ATTN: Document Control Desk
U. S. Nuclear Regulatory Commission
Washington, DC 20555-0001**SUBJECT:****Beaver Valley Power Station, Unit No. 2
Docket No. 50-412, License No. NPF-73
Supplemental Information for Beaver Valley Power Station Unit 2 Spent Fuel Pool
Rerack License Amendment Request (TAC No. ME1079)**

Response to September 27, 2010 NRC Request for Supplemental Information

Response to September 27, 2010 NRC Request for Supplemental Information
Page 1 of 49

Figure 5-1: Rack Drop LS-DYNA Model

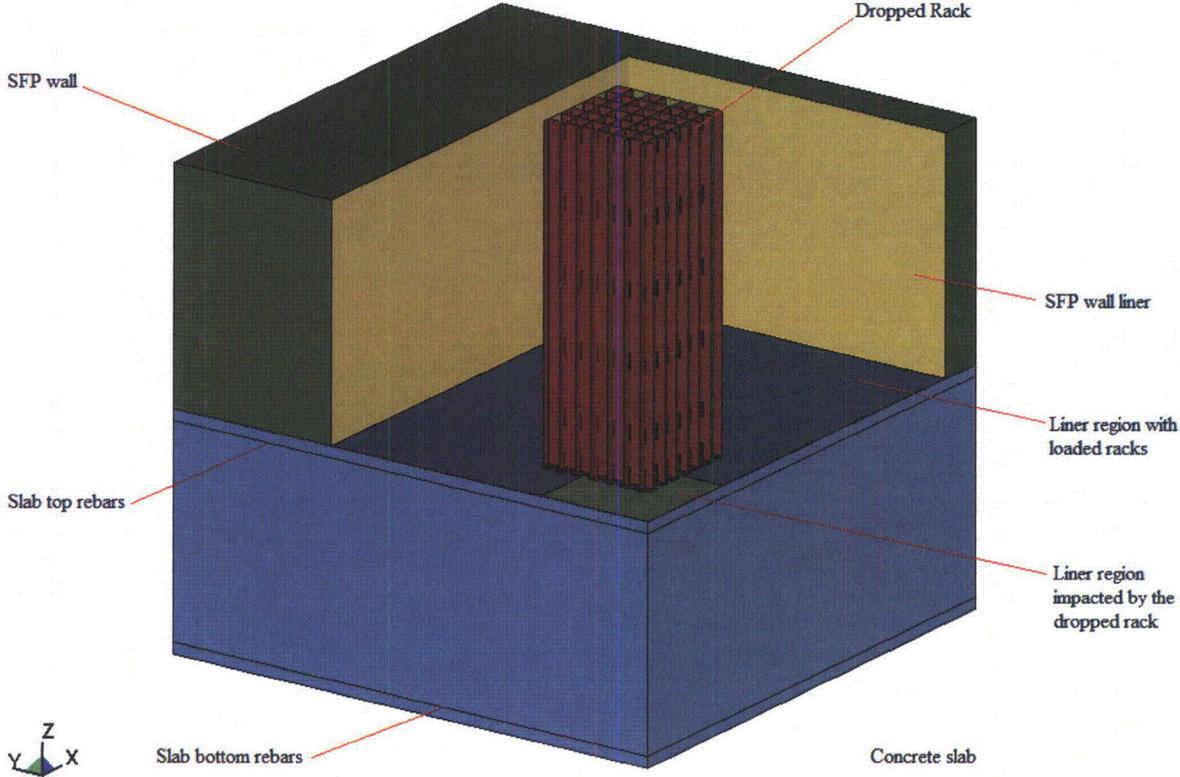
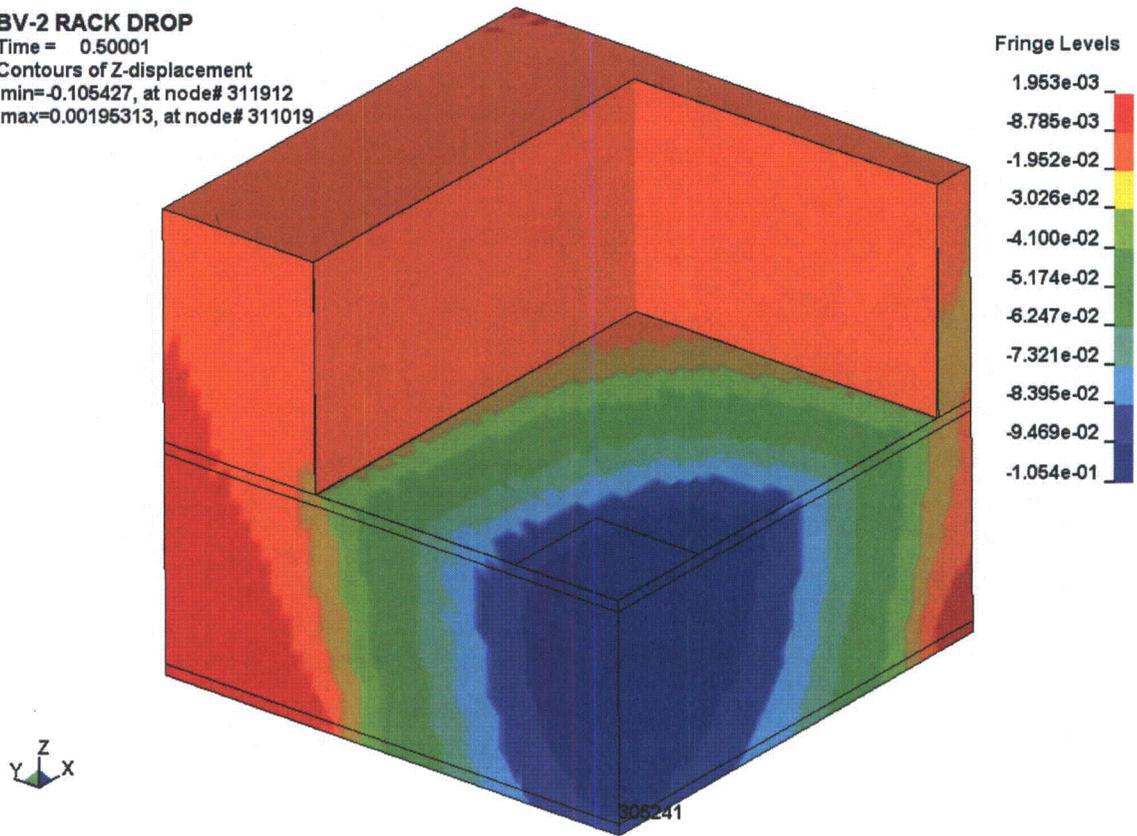
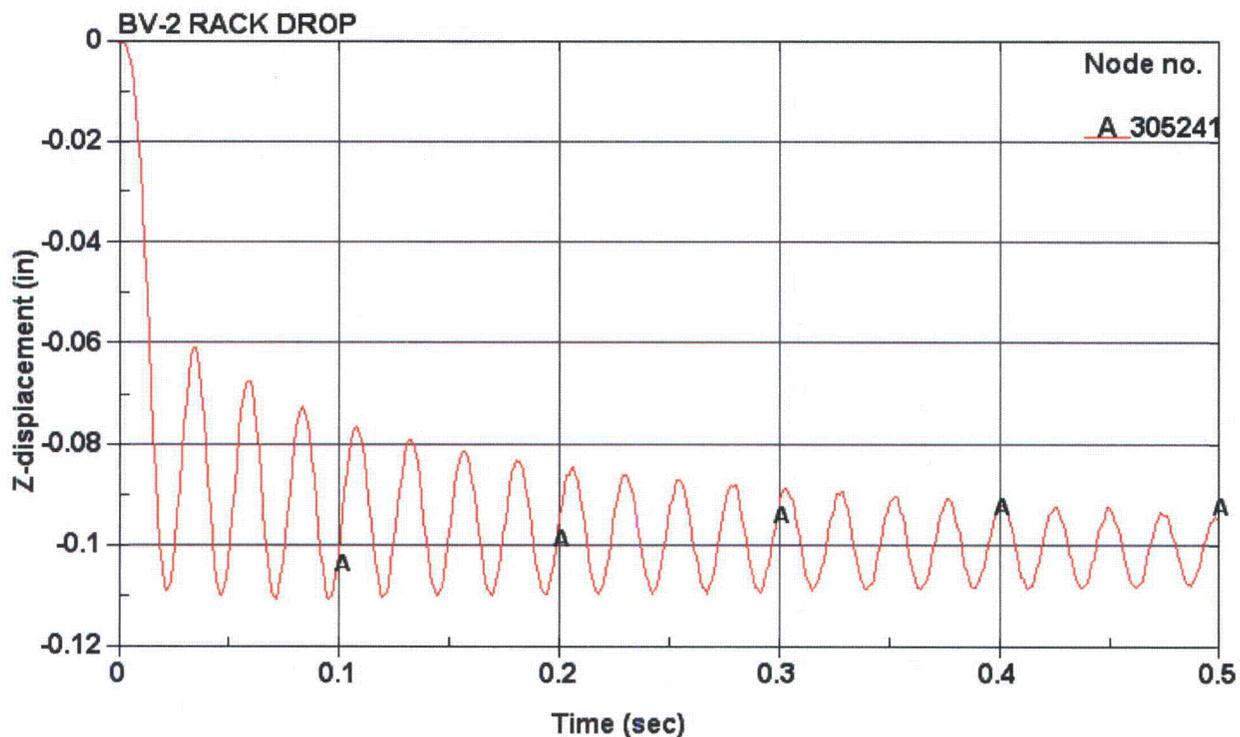
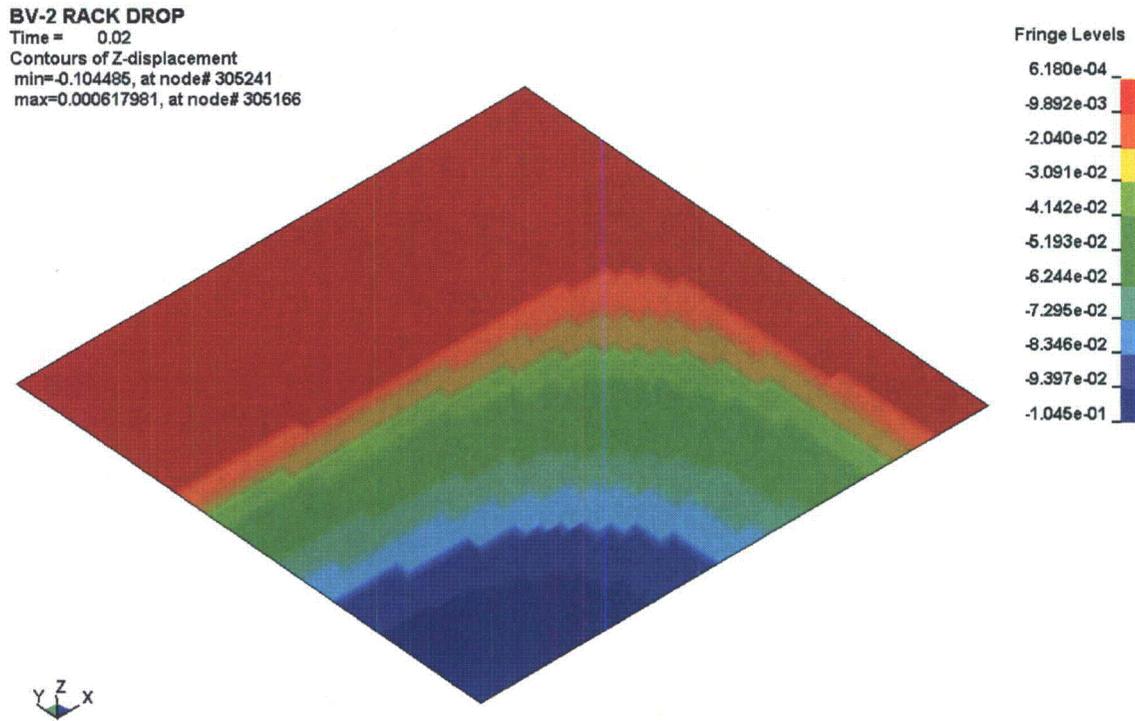
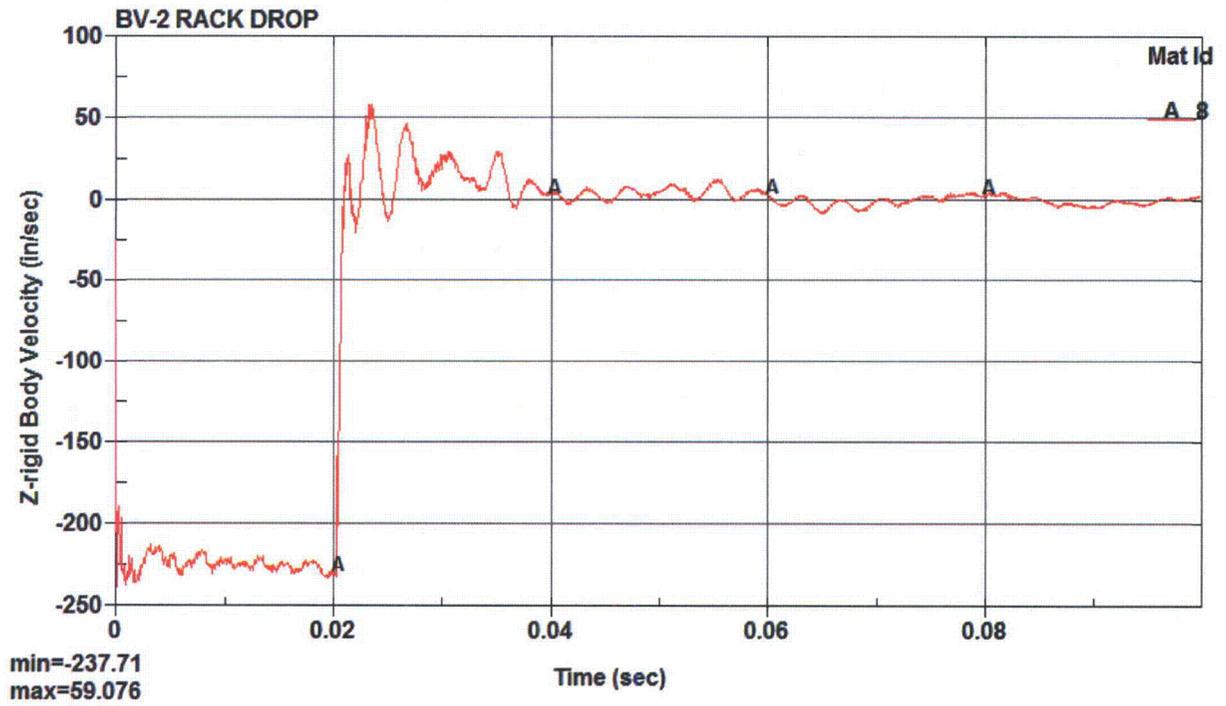
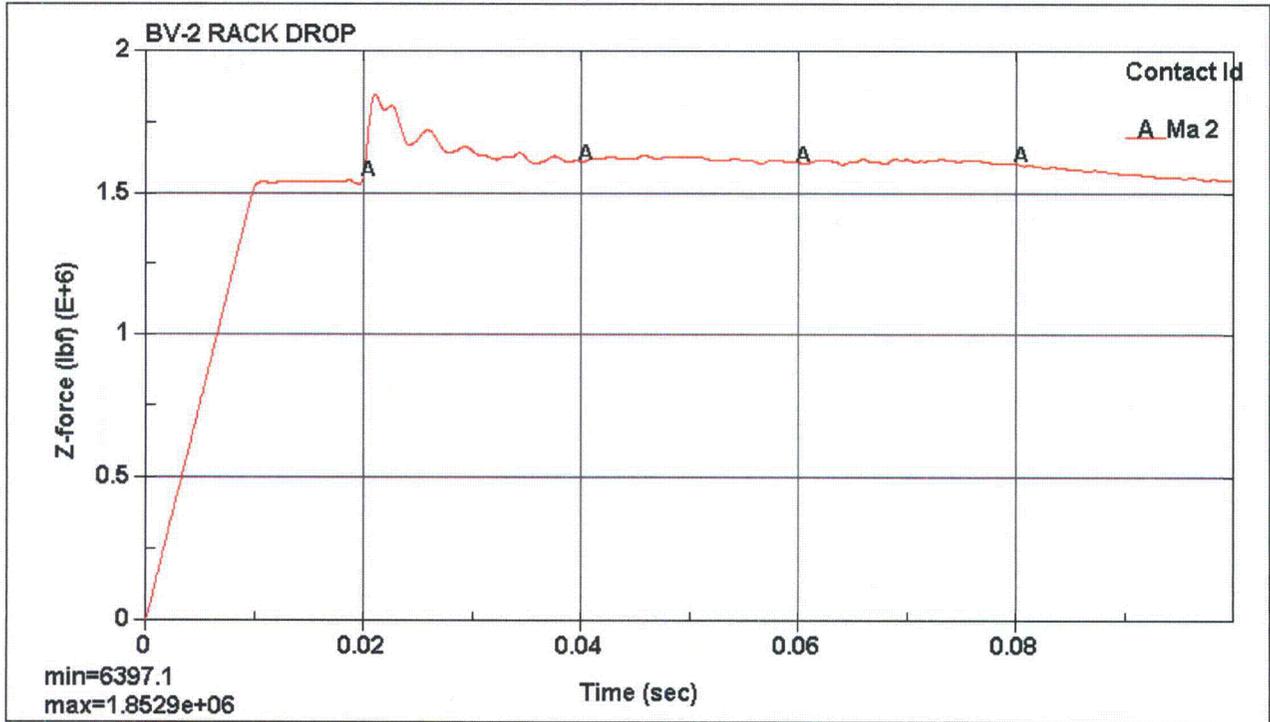
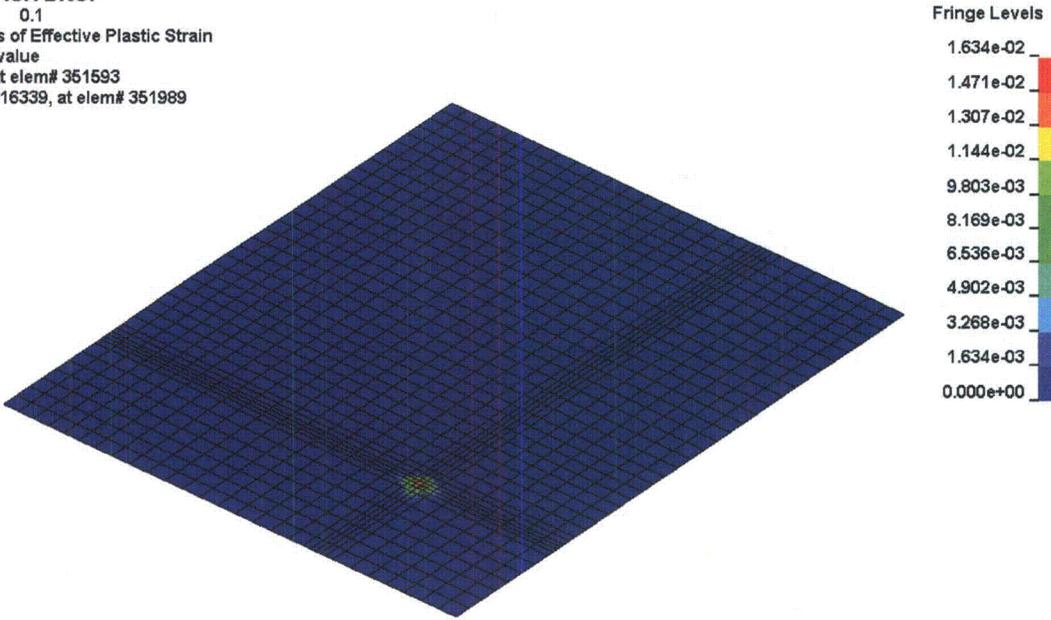
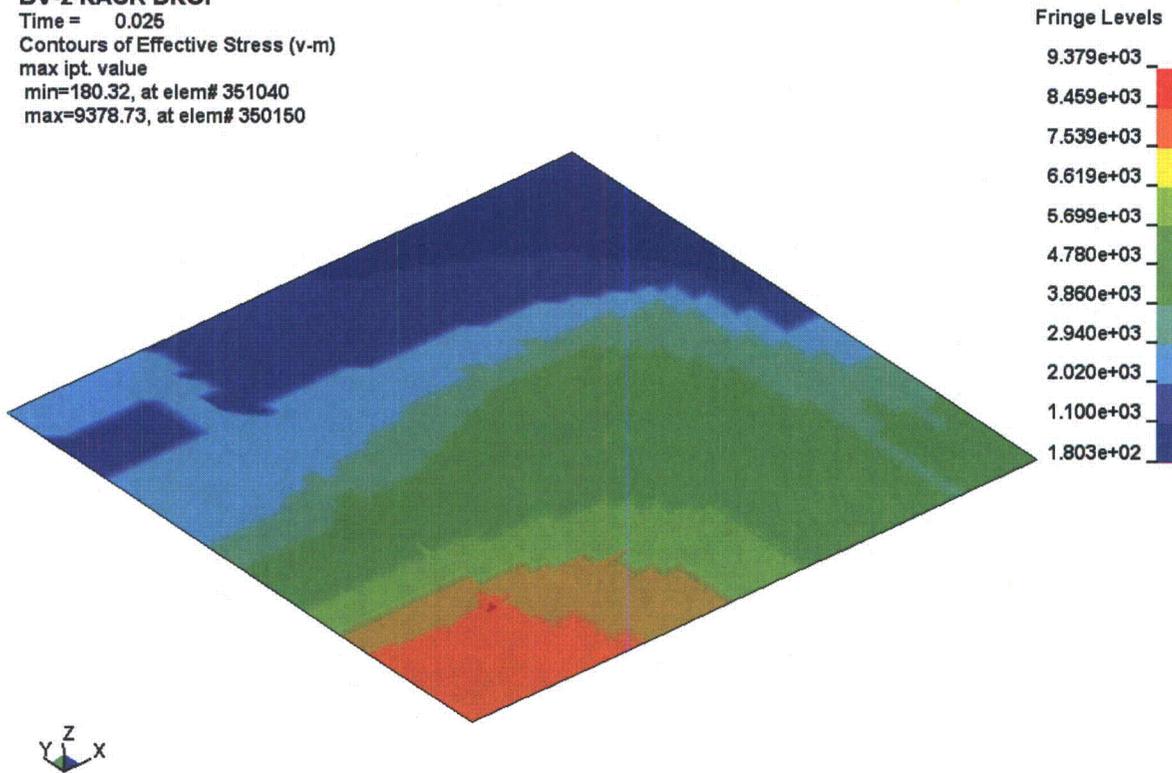
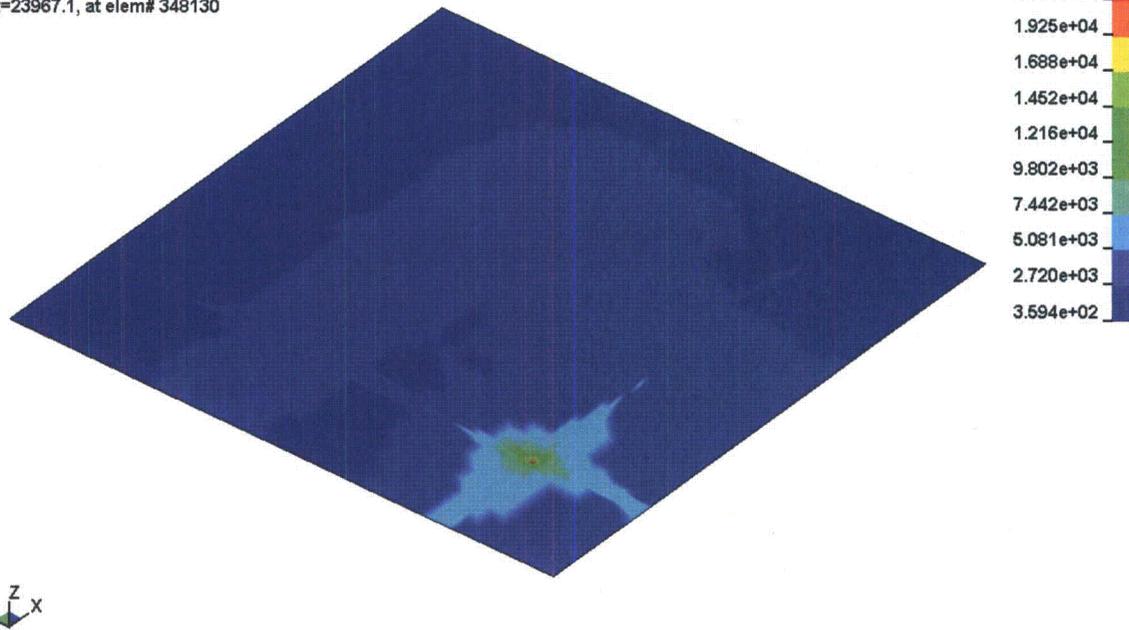
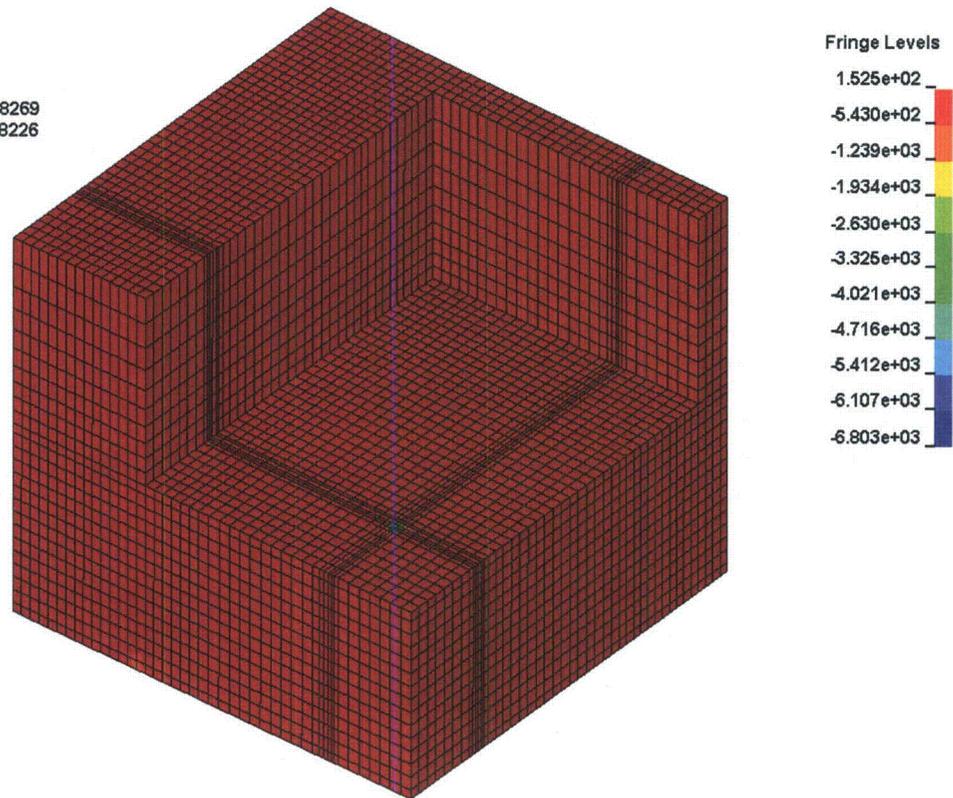
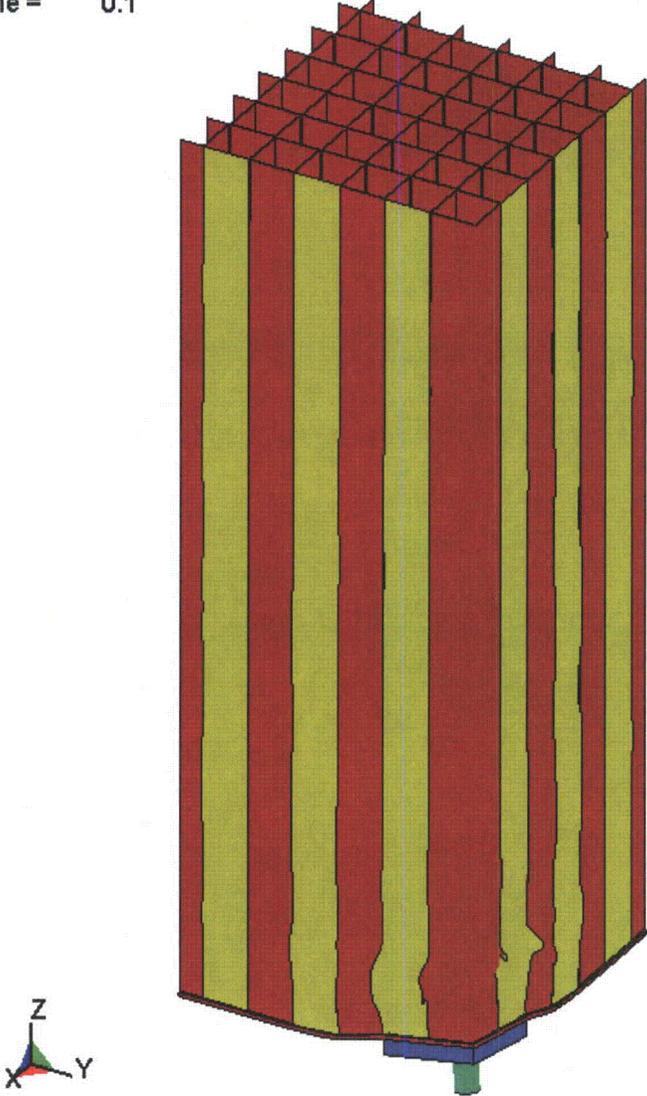
3. Provide the basis for the value of subgrade modulus (260 kips/ft³). In addition, provide further information and confirm that the uncertainty in the value of the subgrade modulus has been taken into account or provide justification that excluding the variation of subgrade modulus has minimal effects on the outcome of the analysis.

In the August 9, 2010 supplemental response, the presented base slab evaluation applied a subgrade modulus of 260 kips/ft³ based on an investigative study performed by Stone & Webster in 1976. The LS-DYNA model in the alternative evaluation presented below conservatively ignores the presence of the SFP slab subgrade material.

Based on engineering judgment that a rack drop accident will not cause a global structural failure of the SFP slab, the initial rack drop analysis was intended to analyze the structural integrity of the SFP floor liner and to evaluate the local damage of the SFP concrete slab. Therefore, only a small region (55.25" long × 55.25" wide × 24" thick) of the slab adjacent to the impact location was considered in the model. To obtain a quantitative assessment of the SFP slab global behavior under the rack drop condition, a revised rack drop analysis that yields both local and global structural responses of the impacted SFP slab was performed.

As shown in Figure 5-1, the revised rack drop LS-DYNA model considers the entire SFP slab as well as a portion of the SFP walls directly connected with the slab. Based on SFP design drawings, the SFP is conservatively modeled as a rectangular structure that envelops the actual configuration of the SFP floor. In addition, the impact is conservatively assumed to occur at the center of the SFP floor irrespective of the actual layout of the racks in the SFP. The symmetry in both geometry and loading warrants a quarter drop analysis model. The modeled (13 × 13 cells) rack is conservatively heavier than the heaviest rack (10 × 14 cells) to be installed in the SFP. The effect of stress state on the failure strain of the material is not considered in the rack model, thereby ensuring a conservative damage evaluation of the SFP slab. In addition to the symmetric boundary conditions applied to the two symmetric planes of the quarter model, the top surface nodes of the partially modeled SFP walls are constrained laterally. For additional conservatism, although the SFP is directly founded on grade, the vertical support offered by the underlying soil is not credited in the model; the bottom of the SFP walls (flush with the SFP slab bottom surface) are vertically supported, making the SFP slab effectively an elevated floor. The SFP concrete structure is modeled with solid elements. The reinforcement of the slab is explicitly modeled as a thin shell at each face of the slab with an equivalent thickness. The SFP liner is also modeled as shell elements.

model. Figure 5-2 shows the deformation of the slab at the end of the slab preloading simulation. Figure 5-3 shows the time history of vertical deformation at the center of the slab bottom reinforcement. These results indicate that the bottom of the slab will eventually have a static deformation of about 0.1 inches under the dead load. As shown in Figure 5-3 and Figure 5-4, the vertical deformation is first reached at approximately 0.02 seconds. In the second simulation (the dropped rack included in the model), the SFP floor dead load is applied in the same manner as in the first simulation but the rack is set a few inches above the SFP liner at time zero so the dropped rack will not impact the liner until 0.02 seconds into the simulation when the SFP floor vertical deformation due to the dead load is fully established. In Figure 5-5, the time instant when the dropped rack starts to impact the liner is indicated. The two-step loading of the SFP slab in the rack drop LS-DYNA simulation is also evident in Figure 5-6, which shows the time history of the total load applied to the concrete slab. For conservatism and consistency, no damping effect is considered in either the preloading or the rack drop LS-DYNA simulations. The table below lists the key results of the LS-DYNA rack drop analysis.

Rack Drop Analysis Key Results		Figure
Maximum (local) plastic strain of the SFP floor liner	0.0163 in/in	5-7
Maximum stress of the SFP concrete slab bottom reinforcement	9,379 psi	5-8
Maximum (local) stress of the SFP concrete slab top reinforcement	23,967 psi	5-9
Maximum compressive stress of the SFP concrete slab	6,803 psi	5-10

Since the LS-DYNA simulation does not directly account for the thermal loading on the slab, the tensile stress in the bottom reinforcement due to the maximum thru-thickness temperature gradient must be added to the calculated stress from LS-DYNA. Based on a maximum thru-thickness temperature gradient of 122 degrees Fahrenheit (conservatively using abnormal conditions), the induced bending moment in the 10-foot thick slab is 255,000 lbf x in/in and the corresponding tensile stress in the bottom reinforcement is 7,280 psi. Adding this stress to the calculated value from LS-DYNA (9,379 psi), the total combined tensile stress in the bottom reinforcement due to the effects of dead load, thermal load, and the postulated rack drop is 16,659 psi, which is below the design basis yield strength of the steel reinforcement (40,000 psi). Therefore, the displacement of the SFP slab is less than its yield point displacement and the ductility ratio of the SFP slab for this event is less than one. Since ductility ratios less than 1.3 are acceptable per Section 3.5.3 of the BVPS-2 UFSAR, the SFP slab has sufficient capacity to absorb the kinetic energy associated with the postulated rack drop. Thus, the postulated rack drop event does not undermine the global structural integrity of the SFP concrete slab.

From a local standpoint, the postulated rack drop accident results in minor plastic deformation in the SFP floor liner with the maximum plastic strain (0.0163) well below the failure strain of the liner material. From the RAI 17 supplemental response
